Project: **11 Faire Road
 Glenfield
 Leicester, LE3 8EE**

Title: **Proposed Side Elevation D**

Job No: **221143** Drg No: **PL-E-005** Rev: **C**

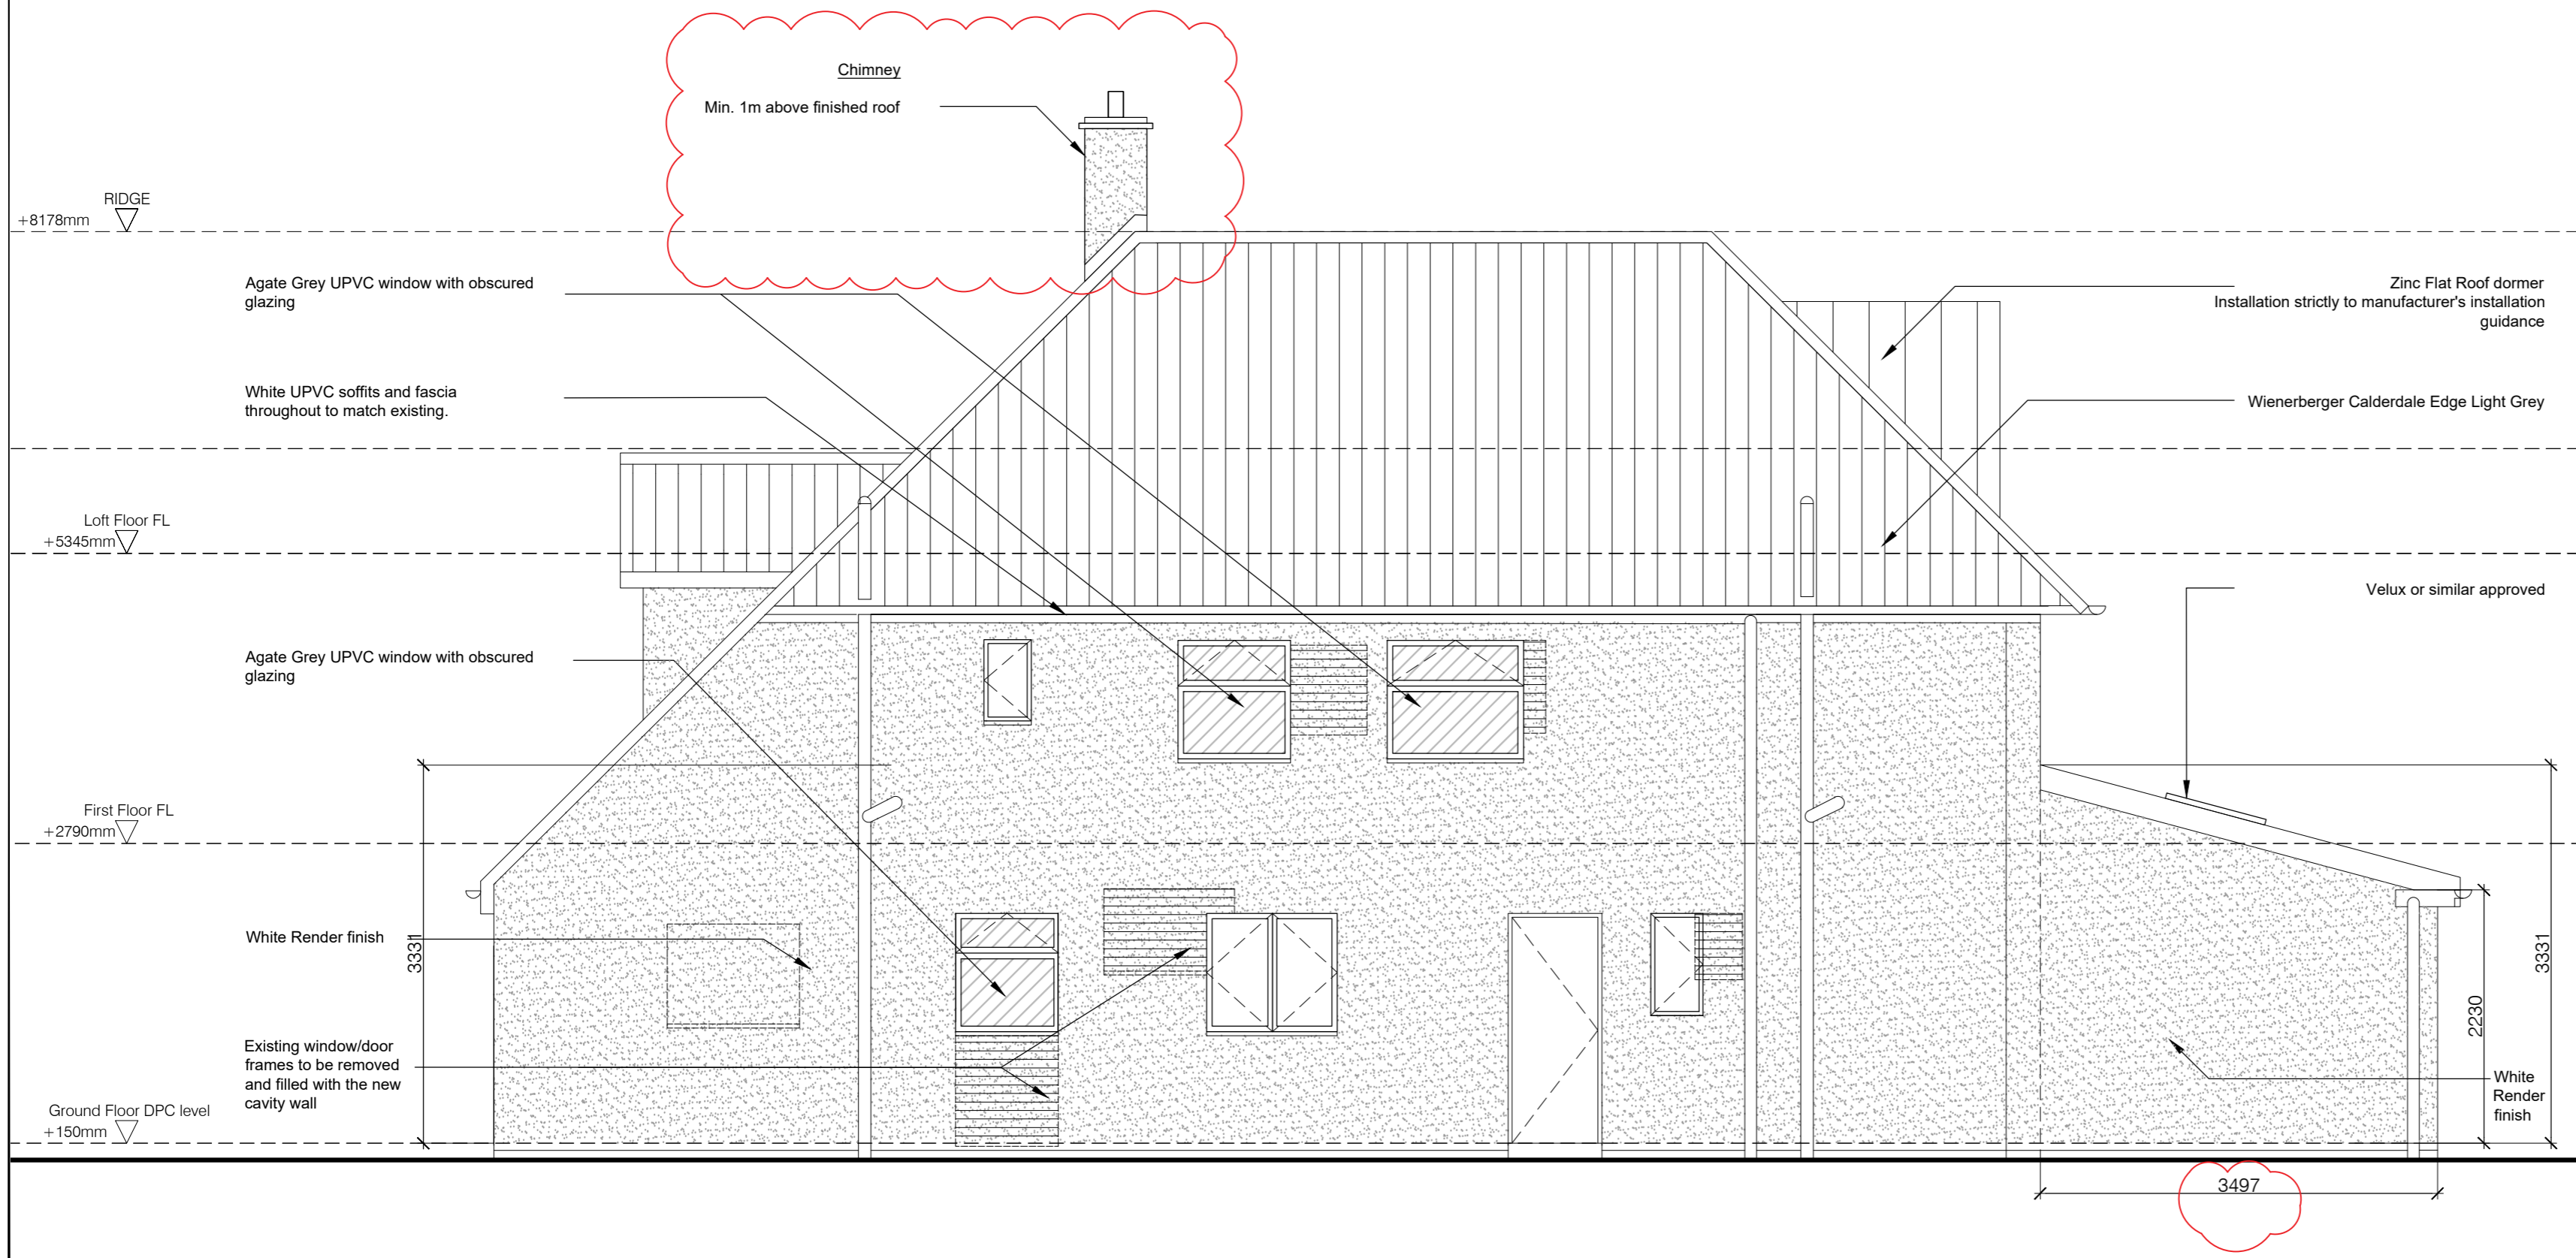
Revision C - KBM - 31.10.23 - October 2023 NMA: 3 no. roof lights indicated on altered key roof plan; chimney dimension altered to meet building regulations; rear dimension revised to as built arrangement
